立法會發展事務委員會

711CL – 啟德發展計劃 – 前跑道南面發展項目的基礎設施工程及
啟德發展計劃進度報告

2015年4月28日會議跟進事項

MASTER LAYOUT PLAN 總平面圖

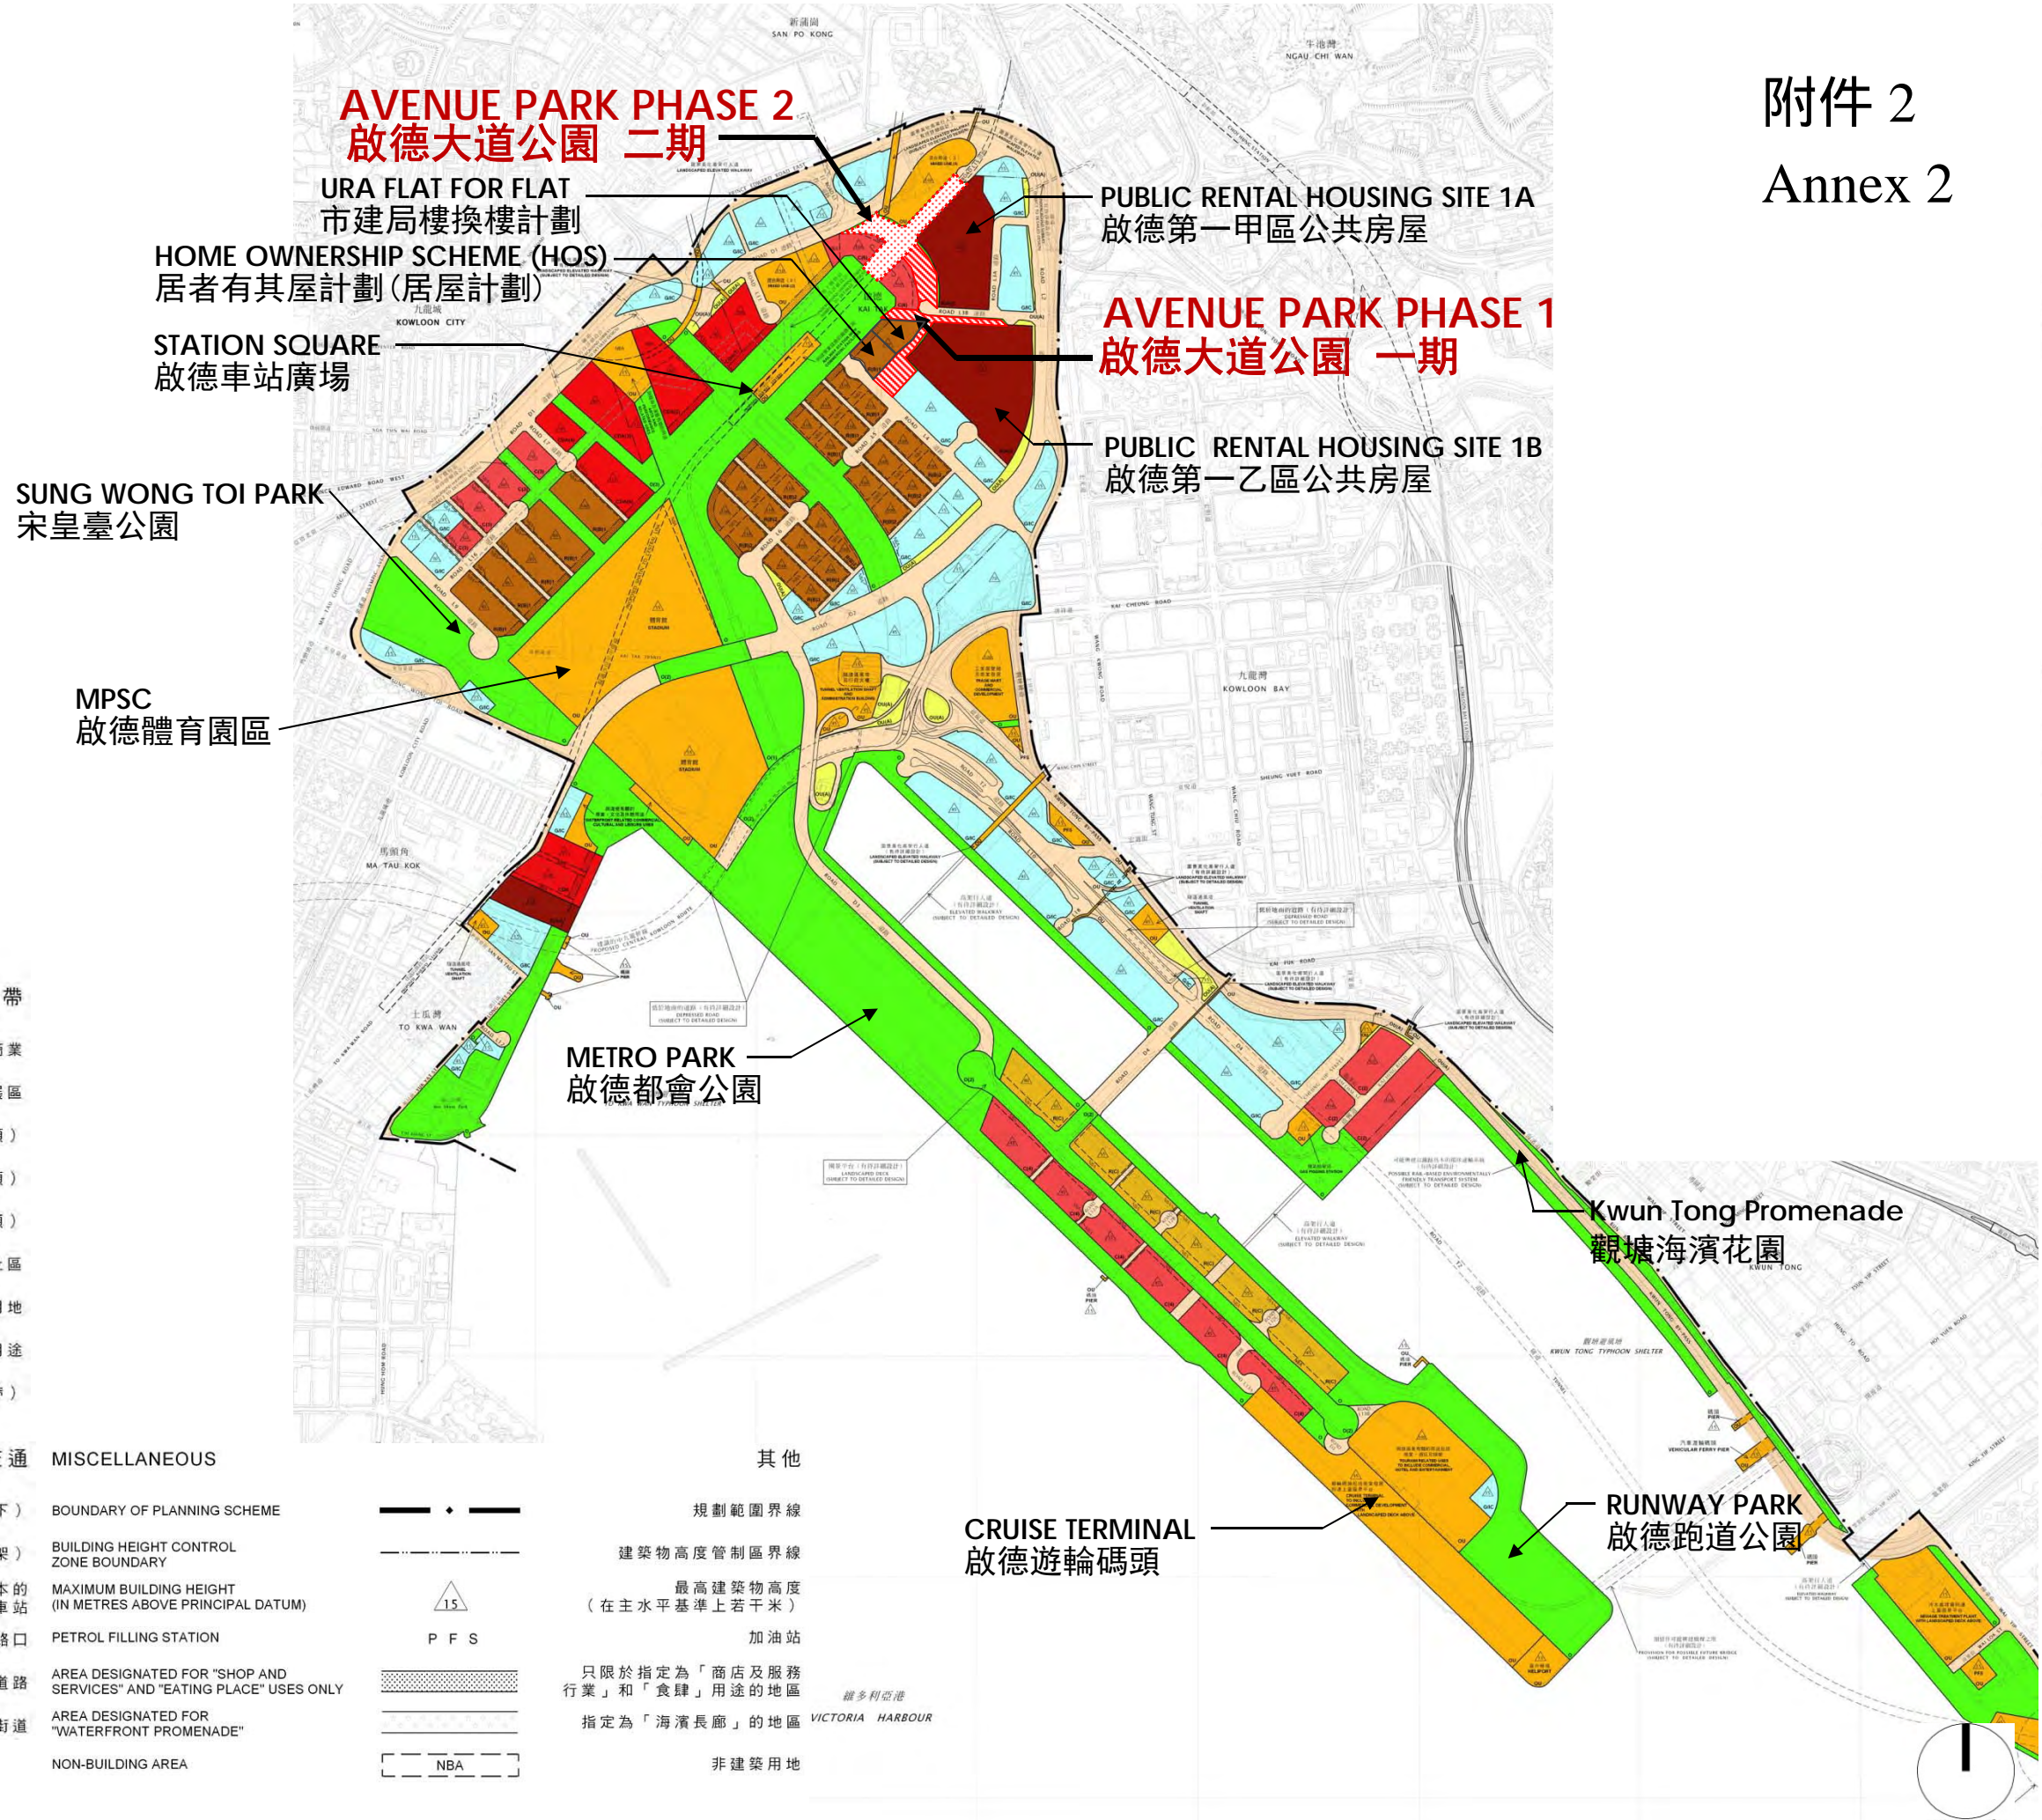
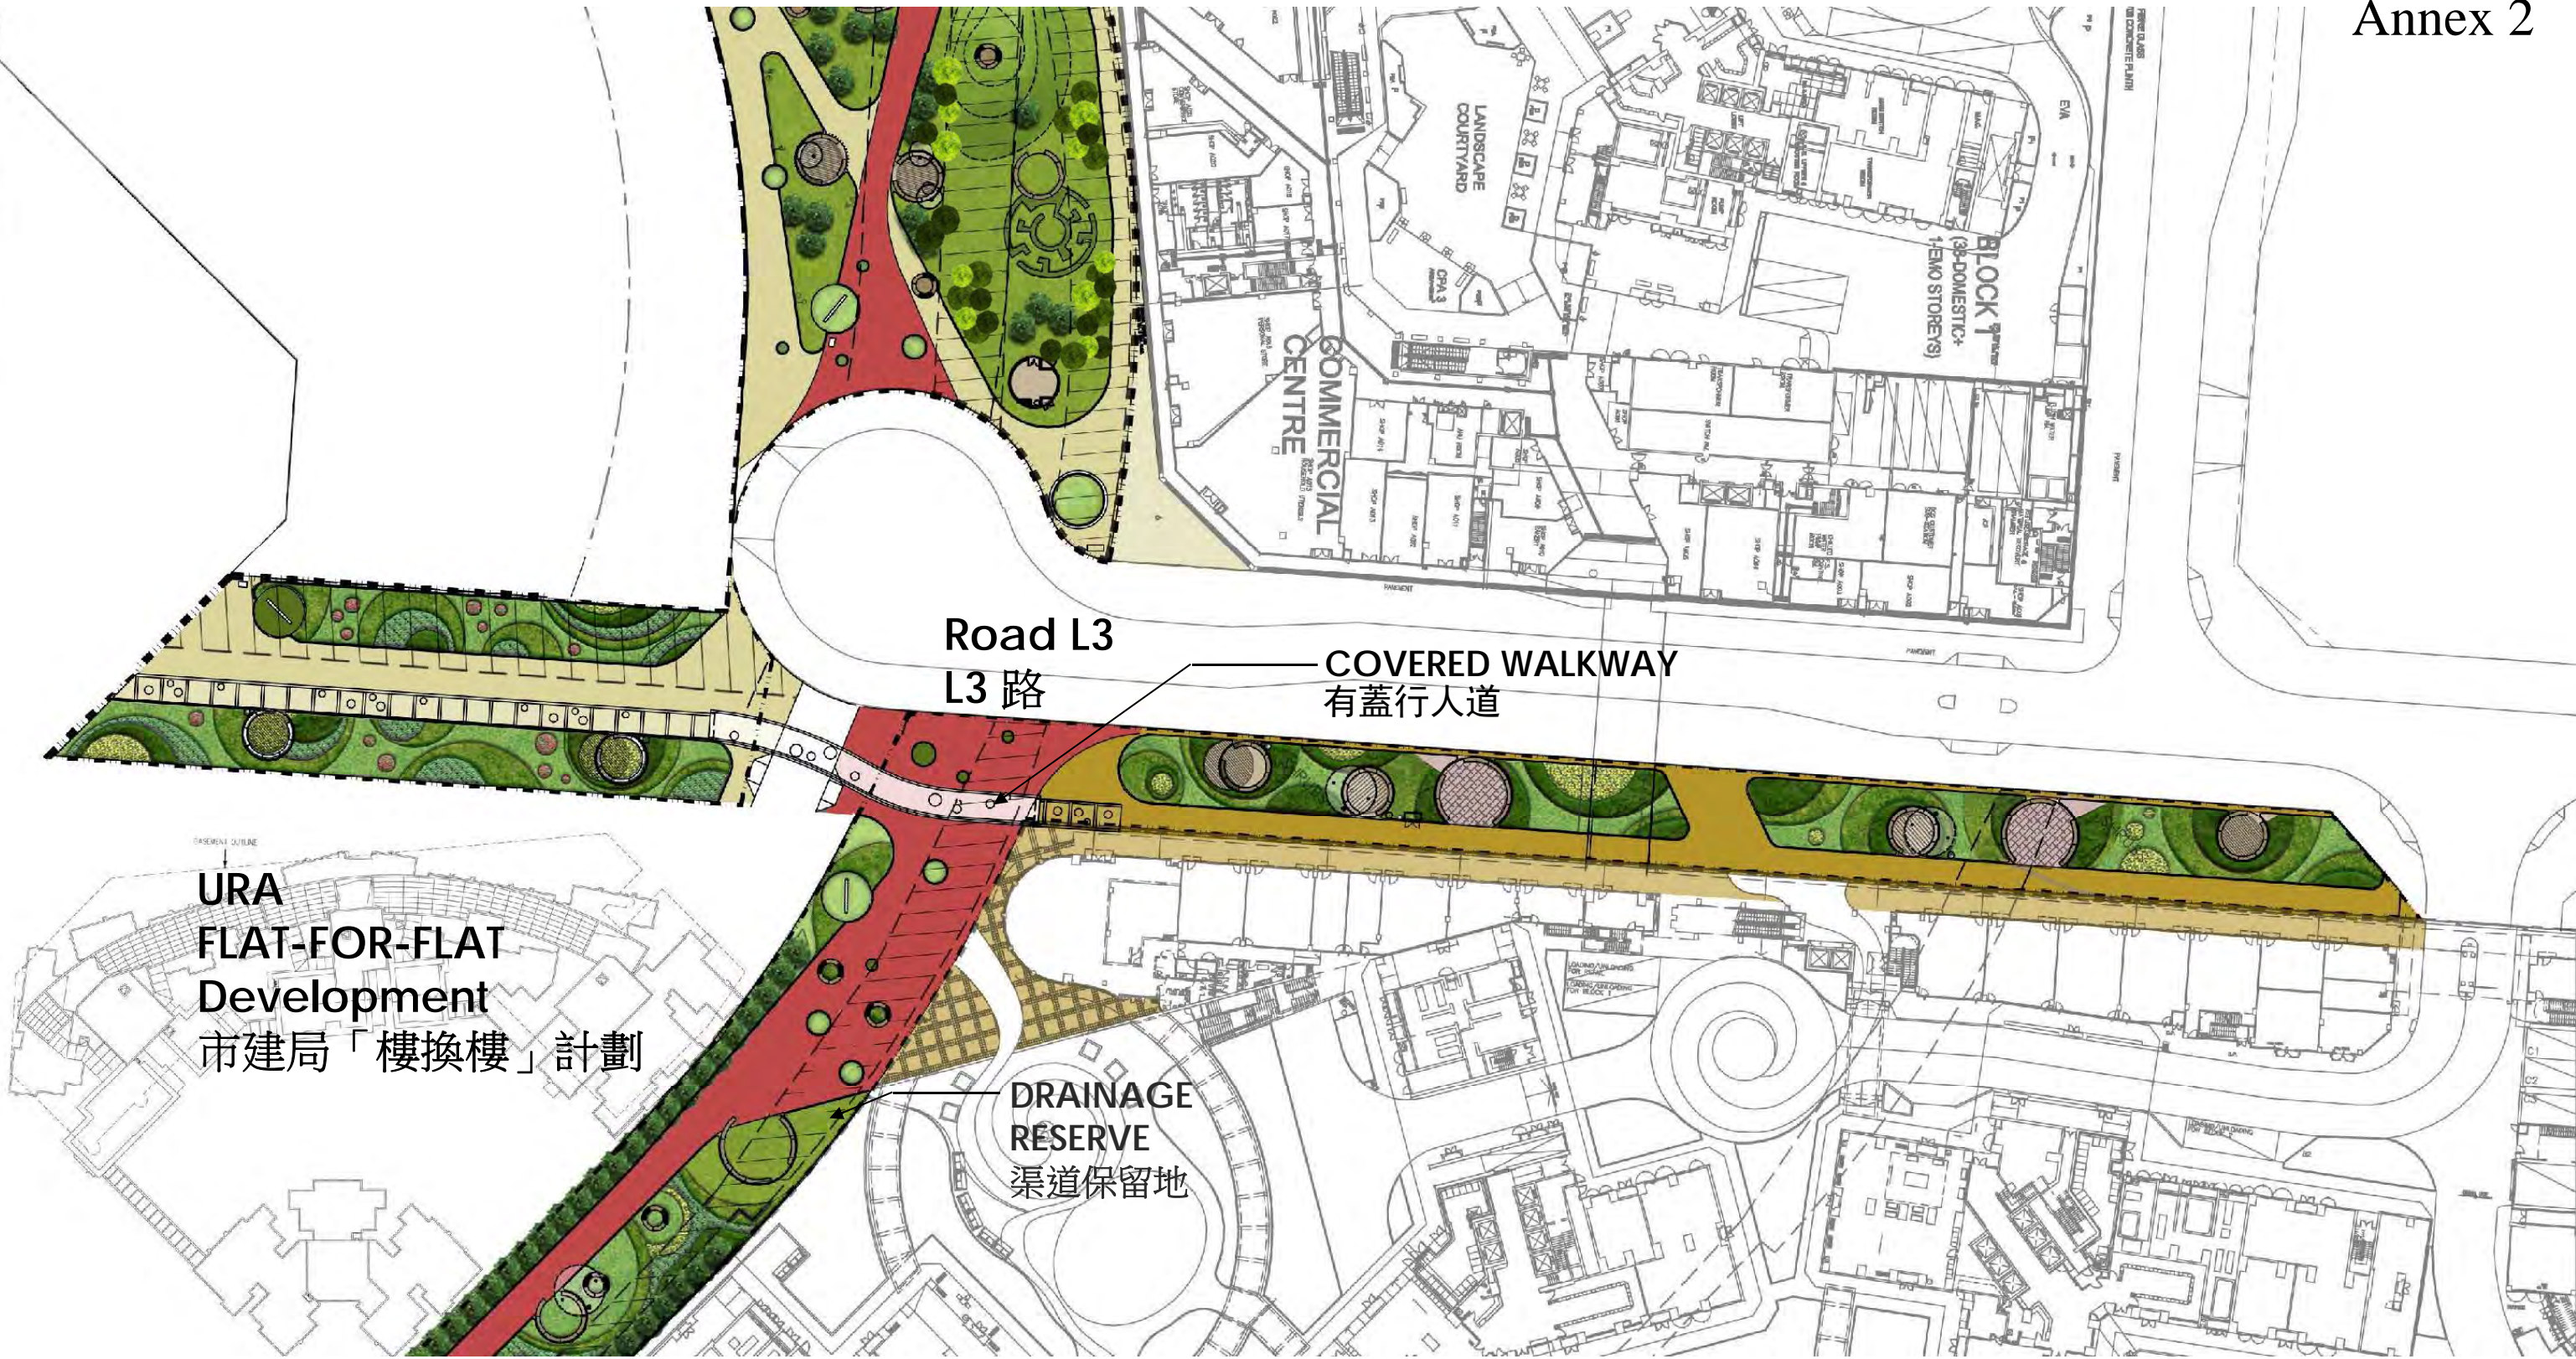
- (b) 就當局計劃於啟晴邨及德朗邨之間提供一個公園，要求提供該公園建造及啟用時間表和公園的平面圖

啟德發展區內啟晴邨及德朗邨附近已預留一幅面積3.2公頃的土地作公園發展之用，由建築署分階段興建並交與康樂及文化事務署管理。第一期公園工程佔地約1.6公頃，其設計已經完成，並已於2010至2013年期間諮詢九龍城區議會及海濱事務委員會轄下的啟德海濱發展專責小組。建議的公園將提供如長者健體設施和園景區等設施，與鄰近屋邨內的康

樂設施(包括兒童遊樂場地、乒乓球桌、羽毛球場、籃球場和五人足球場)互相補足。公園的撥款申請將按照既定的資源分配機制進行。公園的位置及佈局圖載於**附件2**。

圖則名稱 drawing title KZ927

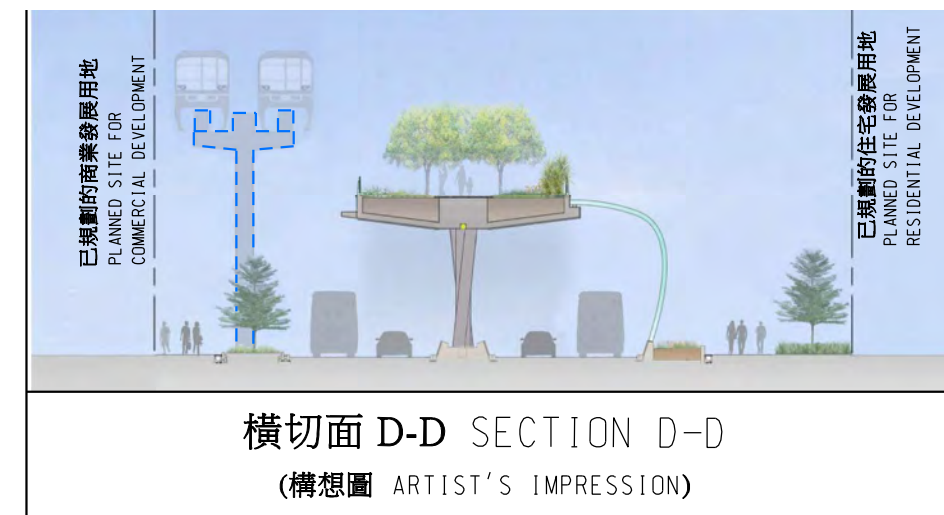
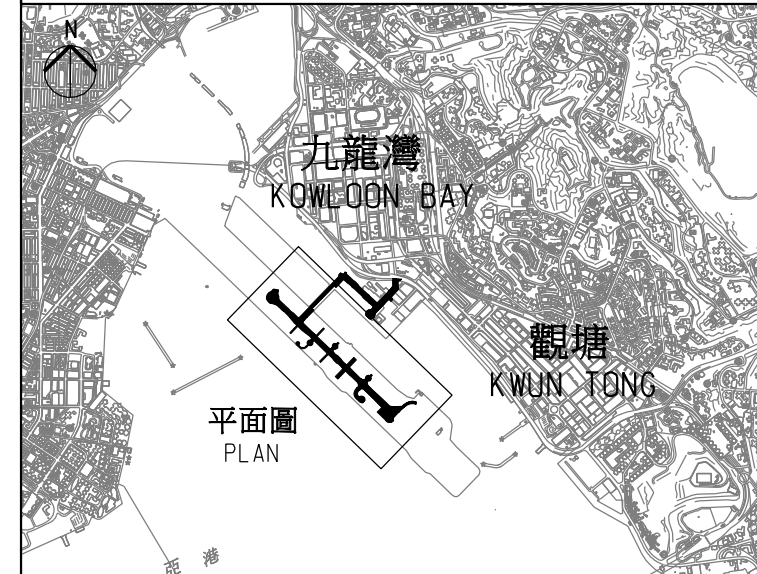
- (c) 就當局於會議上指出，因為技術的限制，難以推行把承豐道建於地底以加強當區的行人暢達性的建議。請以平面圖/圖則(包括剖面圖)，解說為何在啟德發展計劃內設置的區域供冷系統地下冷凍水管道，以及其他公用設施管道，會使上述建議不可行。

- (e) 以平面圖/圖則，包括佈局圖及剖面圖，詳細介紹架空園景平台將如何與環保連接系統交匯。

現有區域供冷系統的廠房建於前跑道南面地底，廠房範圍的土地用途按《啟德分區計劃大綱圖》編號(S/K22/2)原本規劃為休憩用地。及後，為配合擬議雙線雙程行車道及其相關的架空園景平台由海濱遷移至前跑道中央，並置於區域供冷系統廠房之上，有關的用地在《啟德分區計劃大綱圖》編號(S/K22/4)被重劃為「休憩用地(2)」。因此，擬議的承豐道不能建於地底，否則便會與現有橫越整條道路的区域供冷系統地下廠房造成衝突。另外，把道路沉建於地下亦將令其連接至毗連道路(如啟德橋)，及毗鄰發展用地(包括商業和住宅發展用地和啟德郵輪碼頭)十分困難。**附件3**內的平面圖及剖面圖展示了上述的限制。

根據《啟德分區計劃大綱圖》，九龍東的環保連接系統將行走於改道後的承豐道旁的商業發展用地前方。雖然擬議的環保連接系統的模式及未來發展將視乎其詳細可行性研究的結果（該研究有待財務委員會批准撥款），架空園景平台的設計已預留足夠空間以建造將來的環保連接系統，以及在有需要時與該系統可能建議的高架車站結合。**附件3**內的平面圖及剖面圖展示了架空園景平台和可能的環保連接系統(鐵路模式)的連接。

圖則名稱 drawing title KZ909

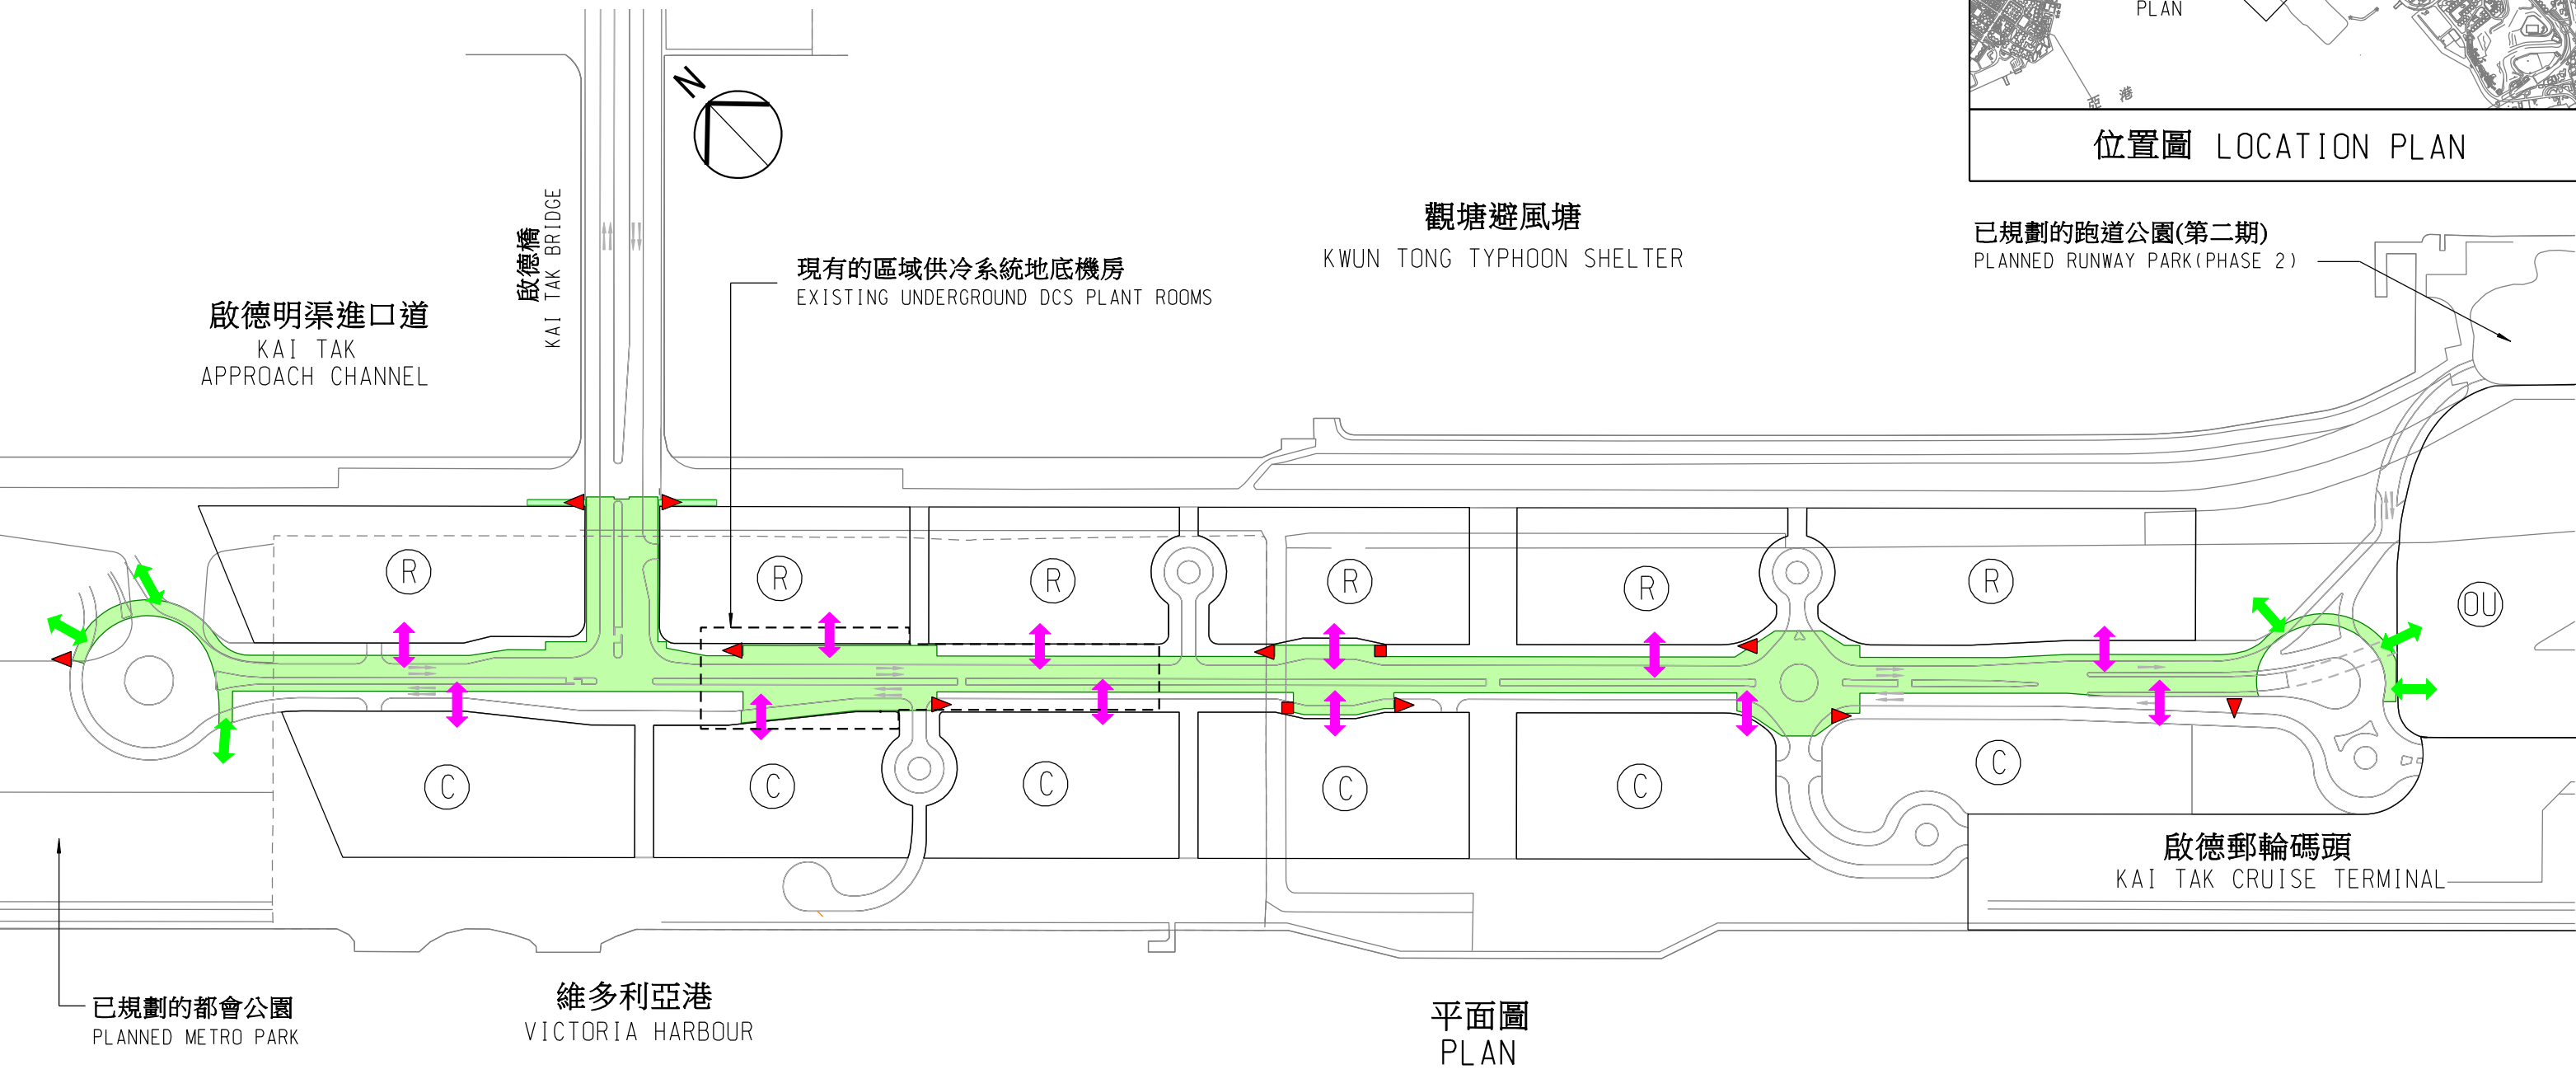
- (f) *詳細說明架空園景平台將如何與啟德發展計劃內的行人設施、商業和其他主要發展連繫。*

- (h) 會否考慮修改有關建議，以使行人或居民可往來架空園景平台和鄰近住宅發展。如會，詳細為何；如不會，原因為何。

架空園景平台將以升降機和樓梯連接改道後的承豐道的行人路及毗鄰發展用地。此外，架空園景平台的設計，已預留接駁點讓日後毗鄰發展項目（包括商業發展）興建伸延以連接至架空園景平台。我們亦已修改架空園景平台的設計，為日後毗鄰的住宅發展預留接駁點。**附件4**內的平面圖展示了有關架空園景平台的行人連接。

我們已修改架空園景平台的設計，為日後毗鄰的住宅發展預留接駁點。附件4內的平面圖展示了有關架空園景平台的行人連接。
